Purpose of study was to identify the effects of restricting School Street traffic flow on the area roadways and intersections.

Primary purpose of study was to identify vehicular impacts of the proposed restrictions to School Street within the study area, and how they relate to pedestrian and bicycle movements.

HAWK SIGNAL
Not to scale

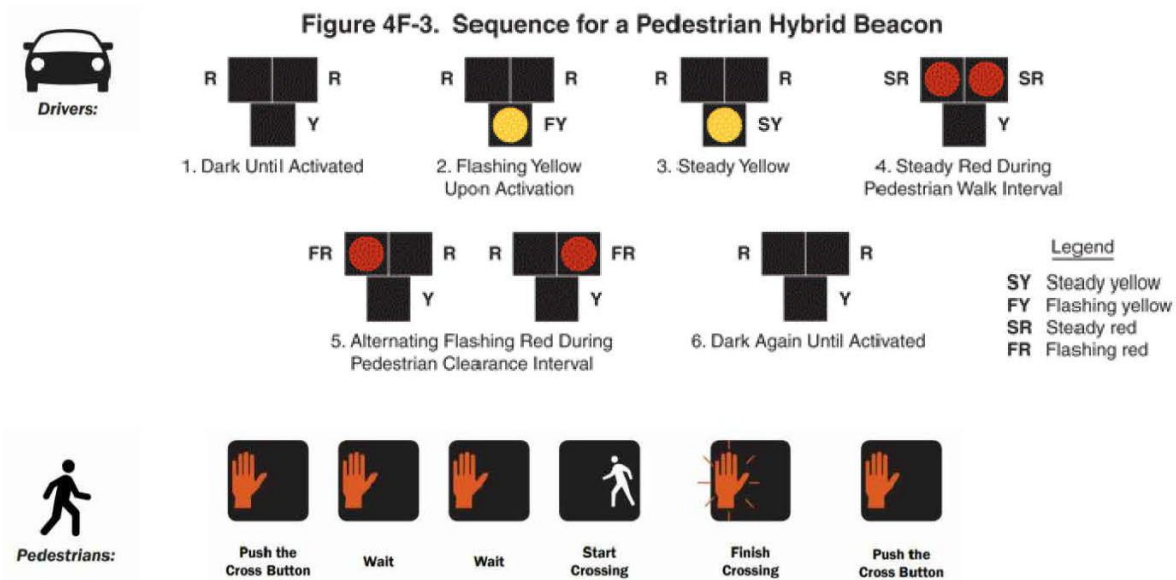
Comments: “HAWKs not recommended for urban environments with frequent ped crossings”, “ pros and cons of ped-activated flashing signal vs full signal”, “option of relying on kids not pushing button is not what we want”, “need studies of HAWK signals improving safety in densely developed urban areas such as north Brookline”

- HAWK signal is similar in operation to full traffic signal with red indication provided to vehicles
- Based on student activity, a full traffic signal may be warranted for installation
- The majority of use would be expected during midday when traffic is lower on School Street
- Specific HAWK signal studies such as has been requested will require additional investigation

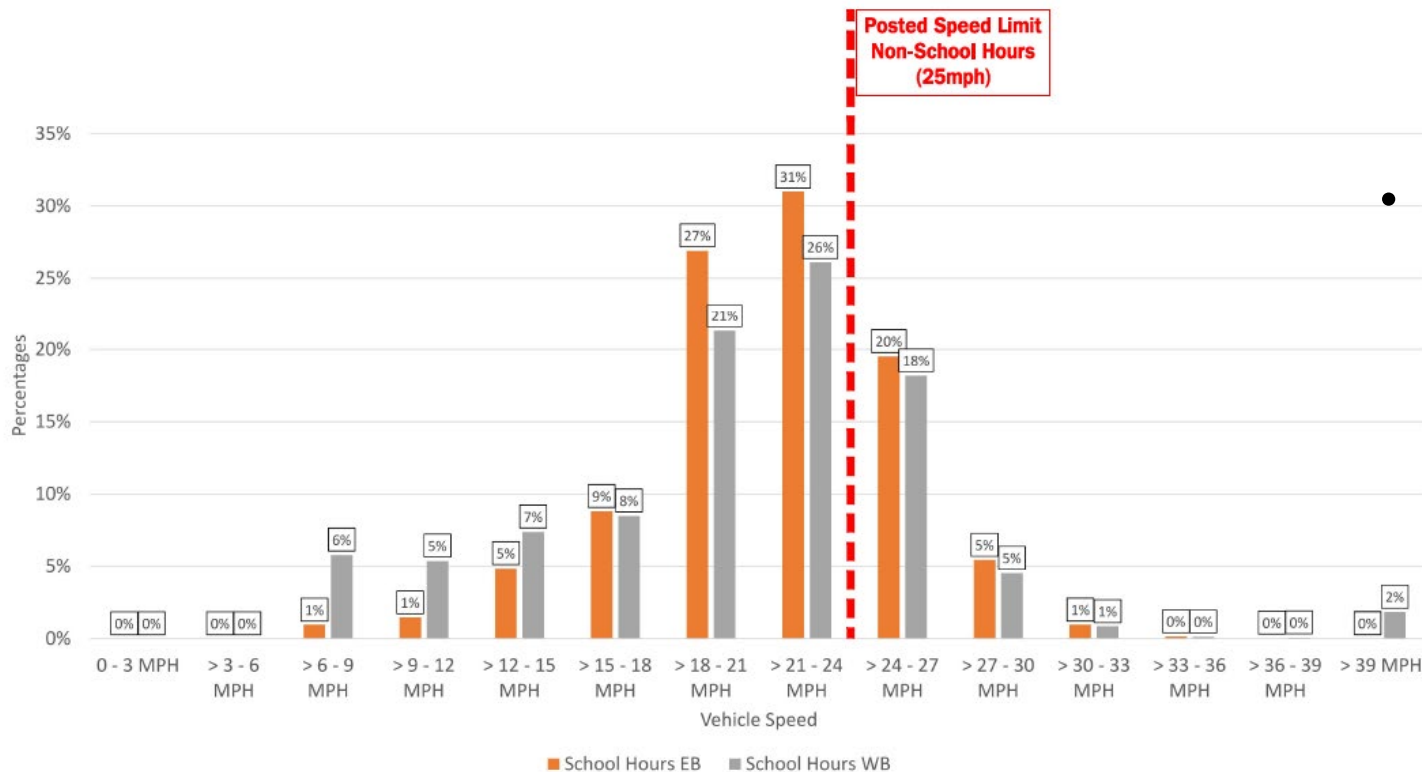
Comments: “too much traffic to speed”,
 “85th percentile speed is only one factor for
 speed limits”, “DOT no longer recommends
 using 85% since 2017”

- We acknowledged that there are vehicles traveling at a much higher rate, and this is not acceptable.
- The 85th percentile speed is still used as a basis for setting speed limits by MassDOT. It can be adjusted downward but not more than 7 mph.
- The proposed speed humps have a proven effect in reducing vehicle speeds. Data from NACTO indicates speed humps can reduce speeds 22 percent, which would drop the 85th percentile speed to 19.5 mph and the average speed to 17 mph.

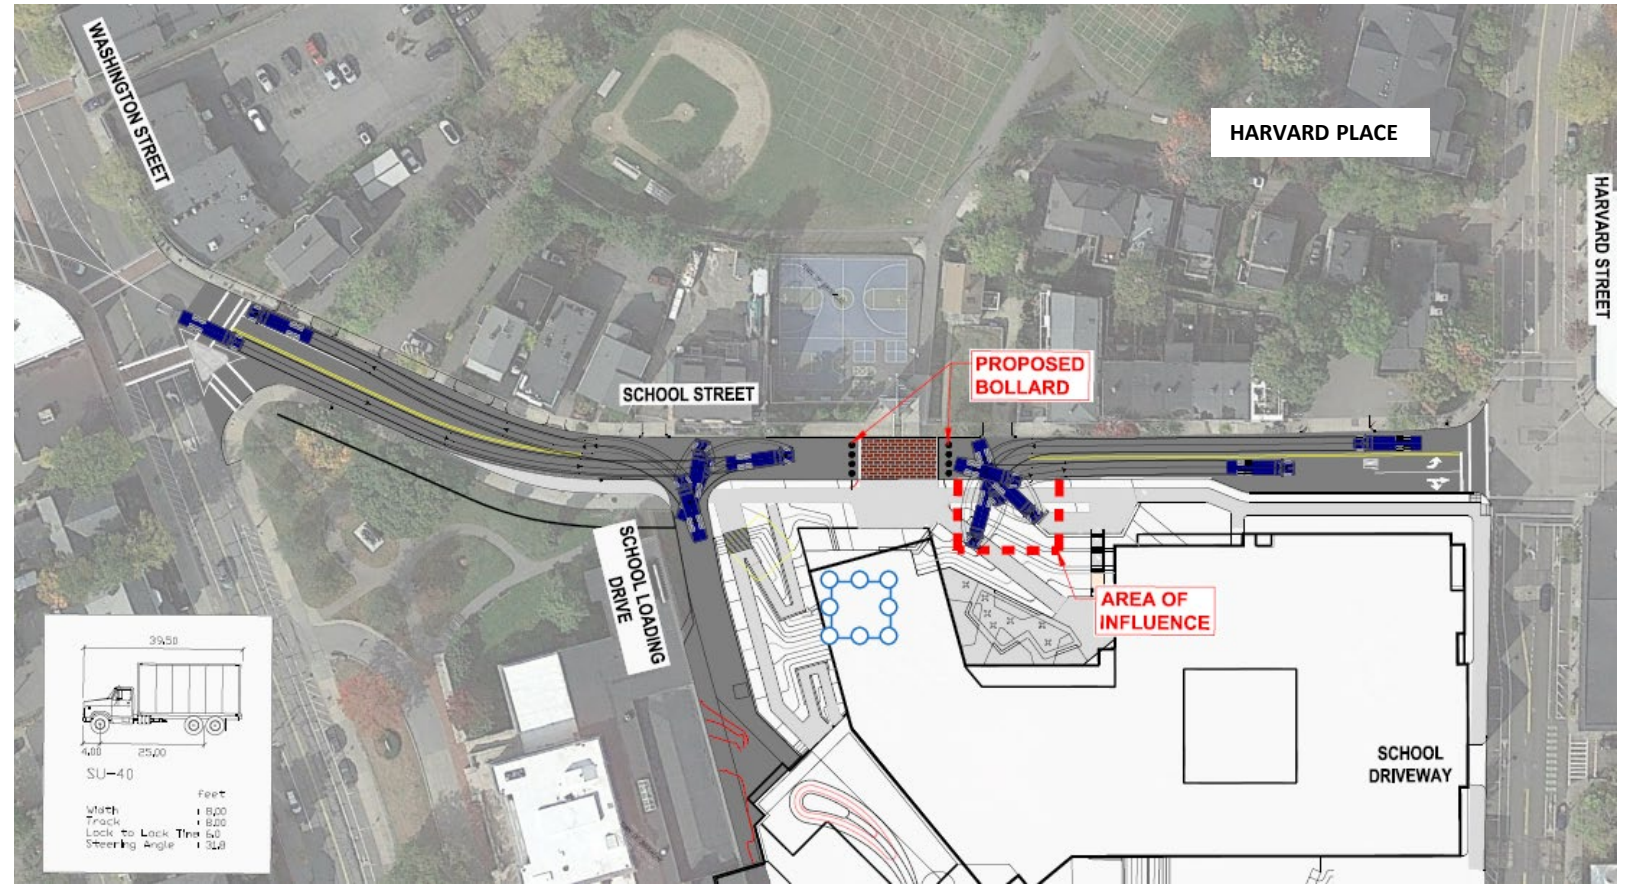
Comments: “...an urban area without cars should be created...”, and “trucks can back into School Street like they do on Harvard Place”

- Focus was on presenting the least impact to area users.
- Trucks reversing into School Street would be backing in through a signalized intersection with crosswalks and a minor street which is a different situation than Harvard Place, with more potential conflict.
